STAFF RECOMMENDATION
712 Fatherland Street
July 17, 2019

Application: New Construction—Outbuilding, Detached Accessory Dwelling Unit (DADU)

District: Edgefield Historic Preservation Zoning Overlay

Applicant: Rich McCoy, rem3studio

Figure 4: Proposed DADU, house-facing elevation

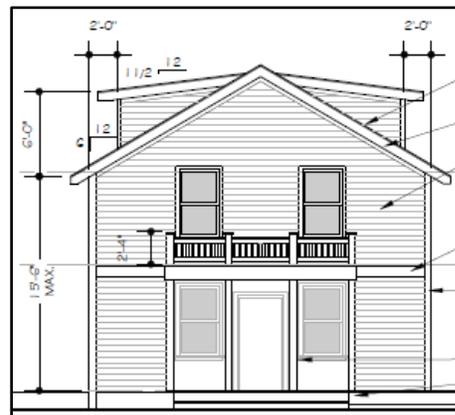
The proposed structure has a simple gabled design with dormers. (Figures 3 and 4) The roof form, materials and overall height are compatible with the surrounding historic

buildings, however the eave height is not. With the reduction of the eave height to no more than ten feet (10'), the proposal will meet Section III.B.h.1 of the design guidelines.

1. Staff shall approve the roof color, windows, doors and garage doors;
2. The ridge height shall not exceed the ridge of the main house as measured from finished floor; and
3. The maximum eave height shall be ten feet (10')

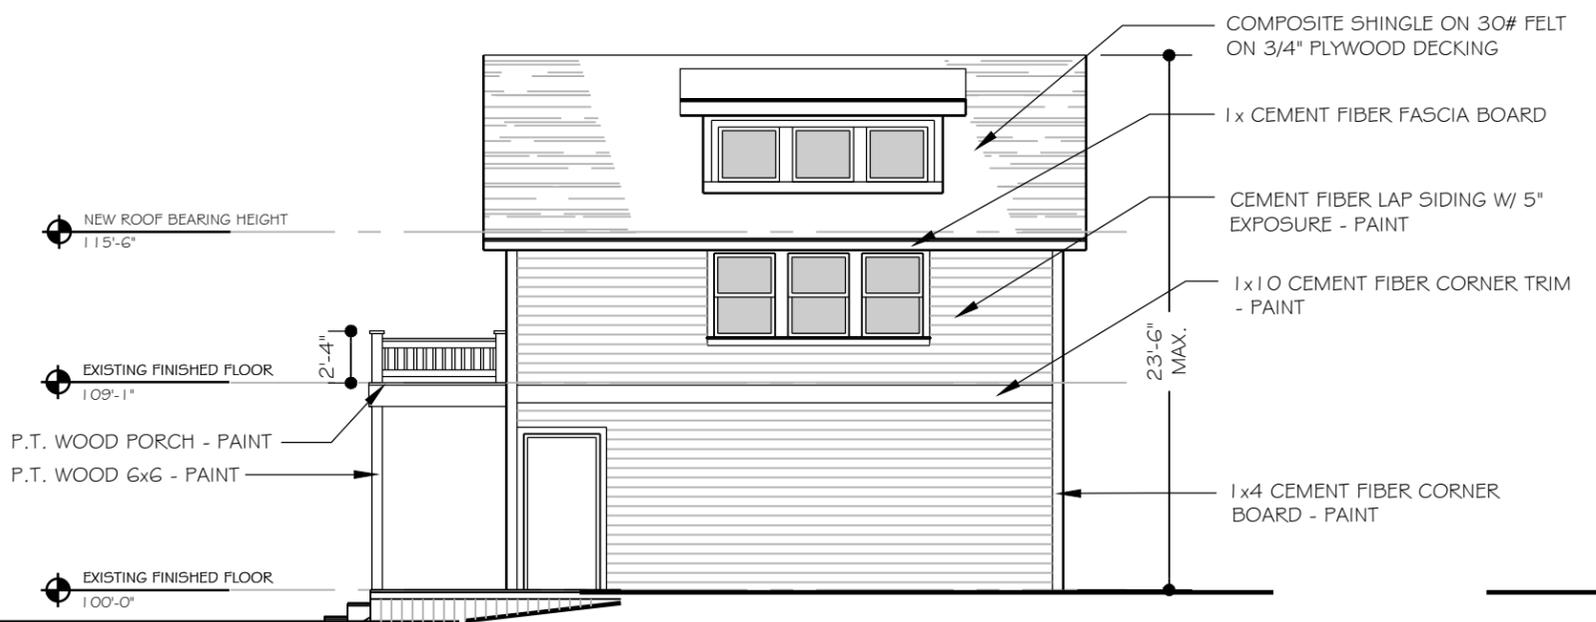
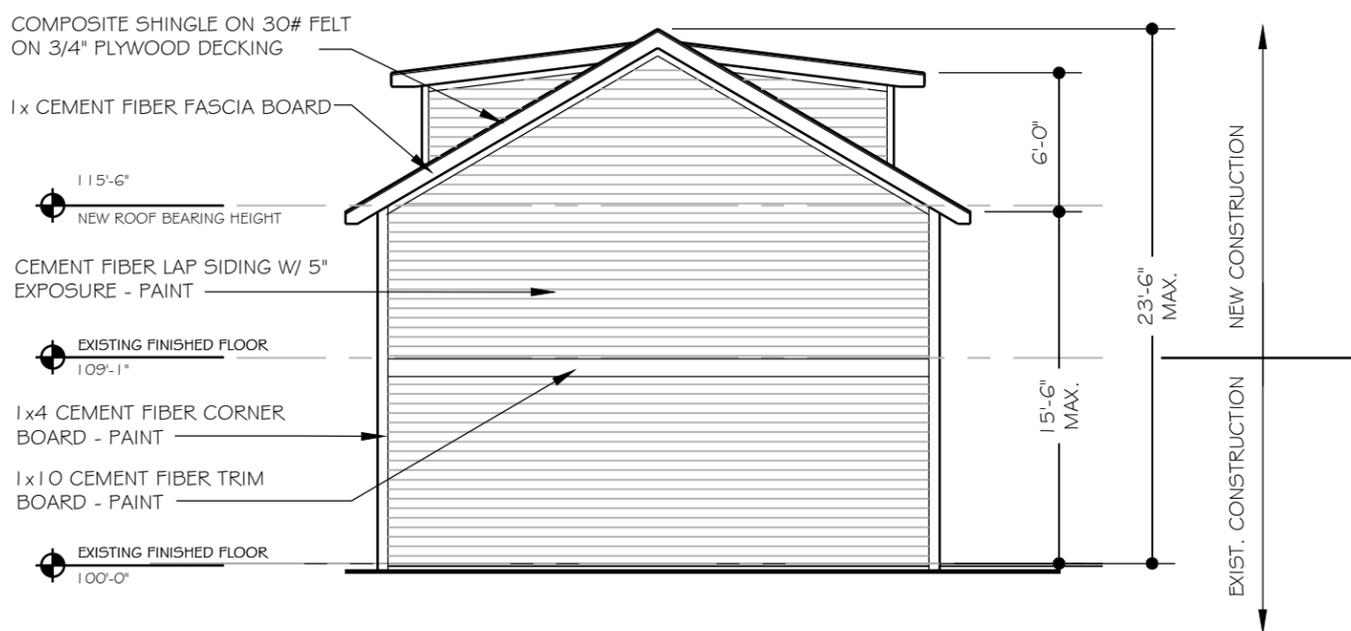
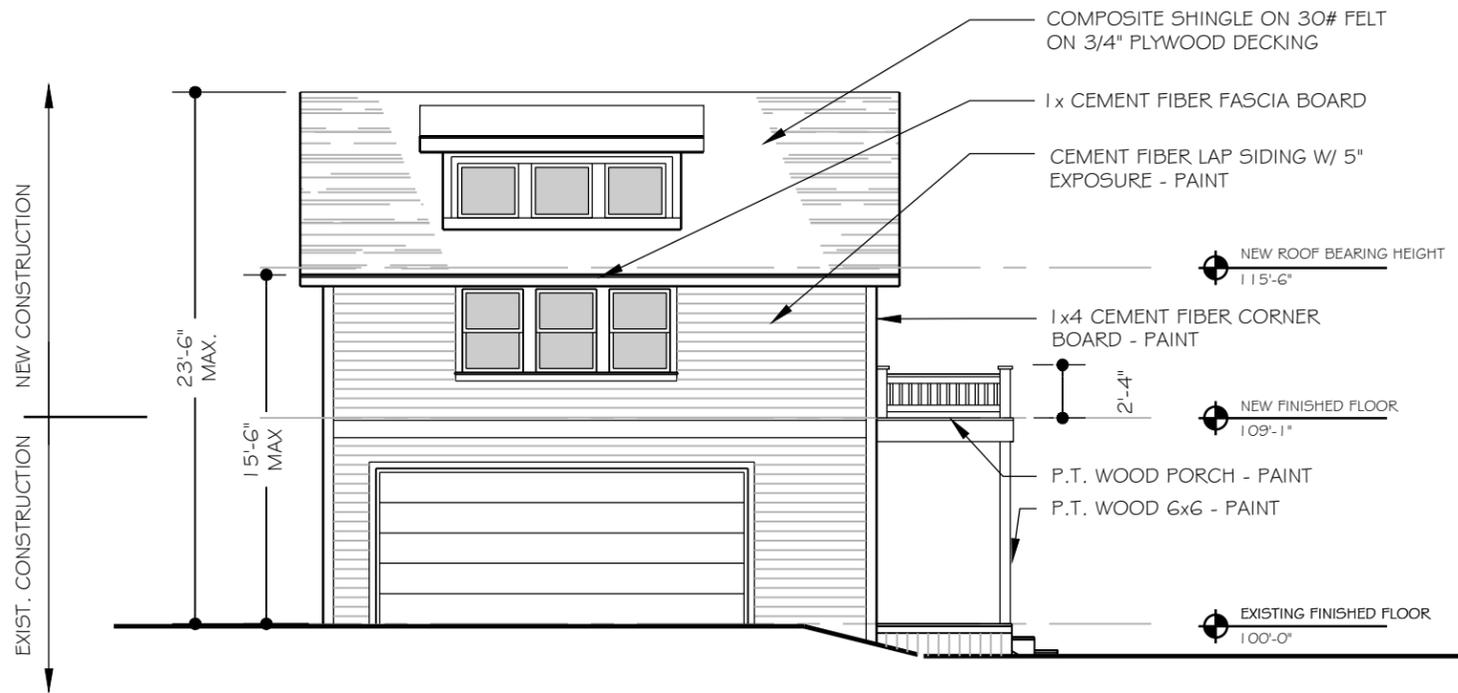
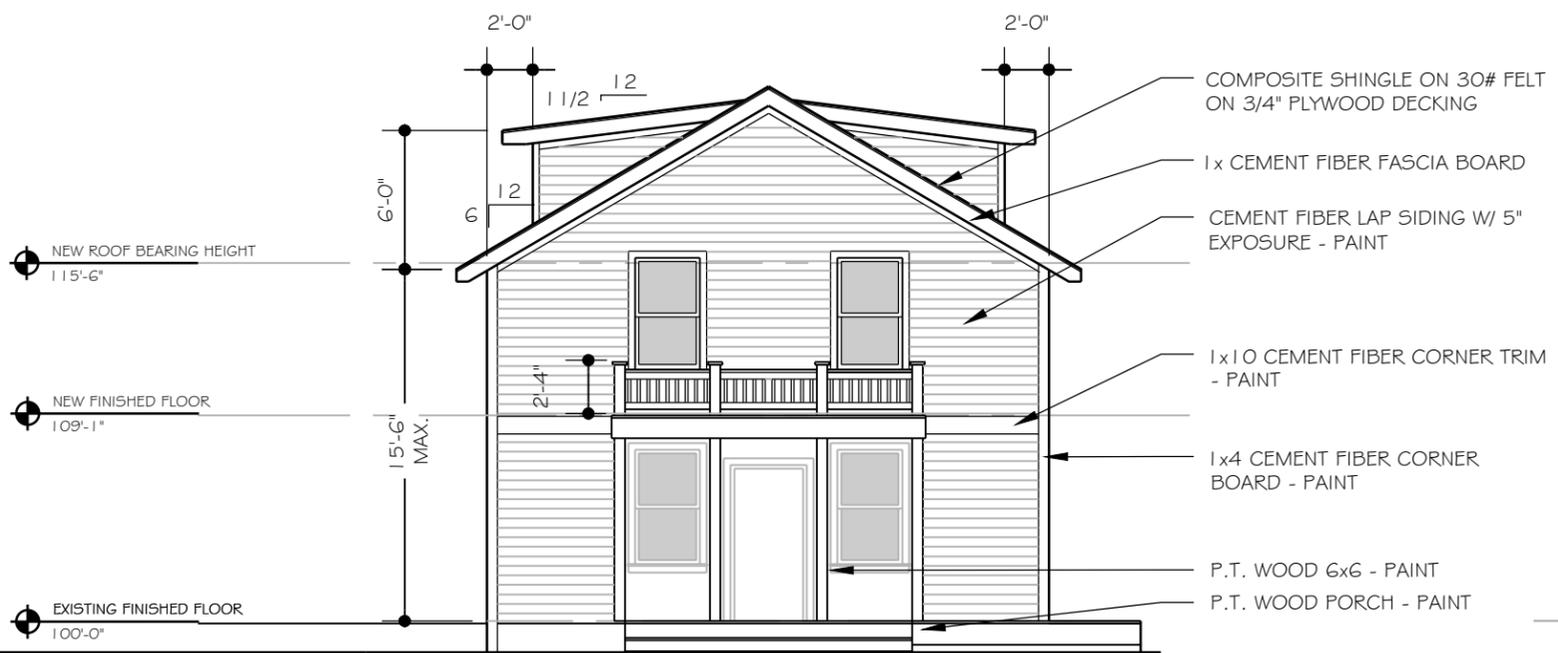
The applicant is proposing a DADU that is taller than permitted by the guidelines. The proposed ridge height will be twenty-three feet, six inches (23' 6") from grade. This height falls under the twenty-five foot (25') ridge height cap. However, the ridge of the primary house, as measured from finished floor height, is approximately twenty feet (20') tall. The proposed eave height is fifteen feet, six inches (15'6"). The historic house itself is a tall one story, with an average eave height of about fifteen feet (15') from finished

floor. In the past, the Commission has determined that when the historic house is one story tall, the DADU eaves need to meet the ten foot (10') requirement, even if the eaves on the historic house are taller.

Staff finds that if the ridge height is no taller than the ridge of the existing house as measured from finished floor and if the eave height is reduced to be ten feet (10') or less, the proposal will meet Section III.B.2.h.1 of the design guidelines.
